Infiltration

Infiltration used by the Applicant and agreed by RIDEM to reduce the volume of flood flow

Proposed Gooding Avenue Hotel

Project Name: Gooding Avenue Development

Infiltration Variations by Soil Texture

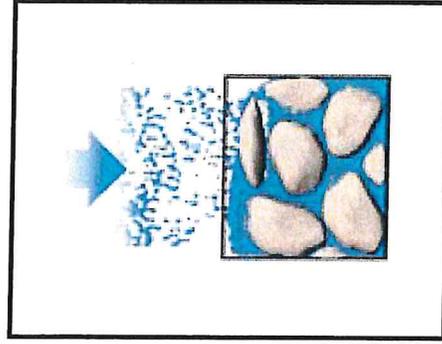
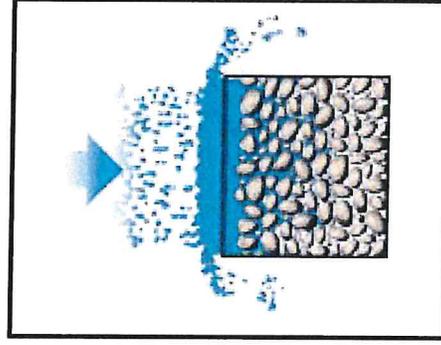
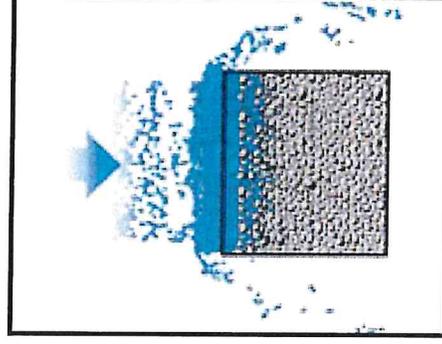
The applicant used a higher infiltration rate than the soil can absorb for Pittstown soils. Stissing soils is a wetland soil.

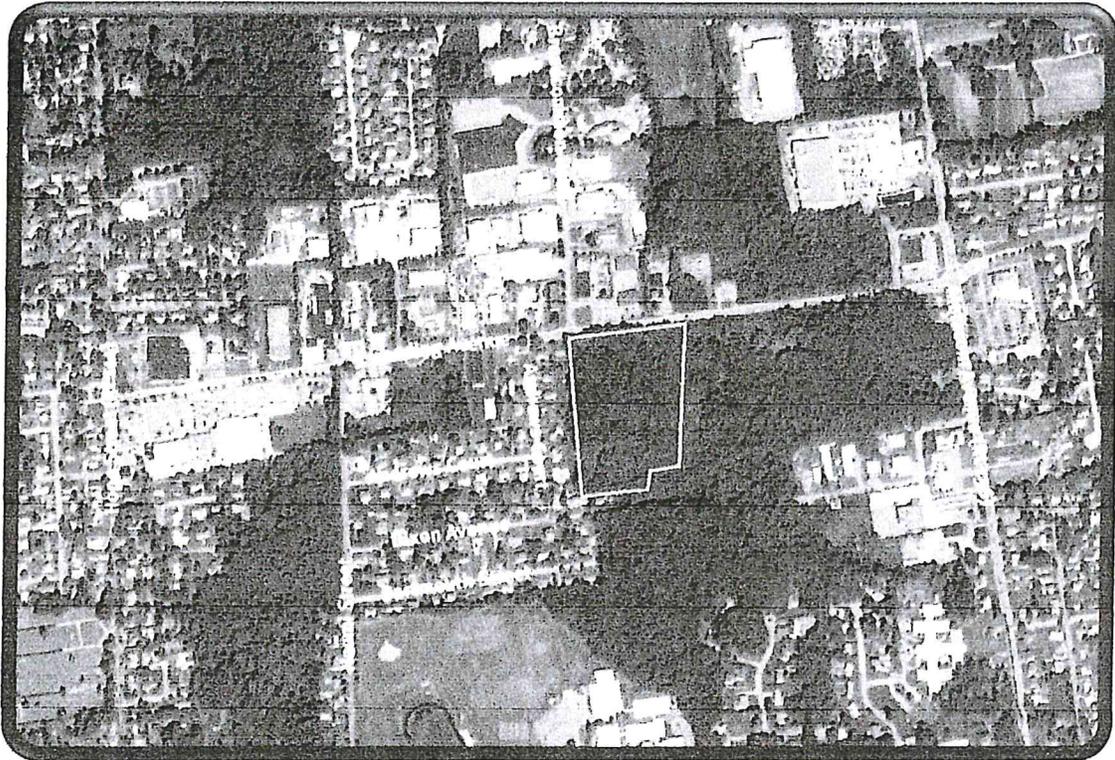
Applicant's In-Field
Soil Observation
classified soils as
Sandy Loam

Soil Samples & Tests have classified the soils as
Fine Sand, Silt, and Clay
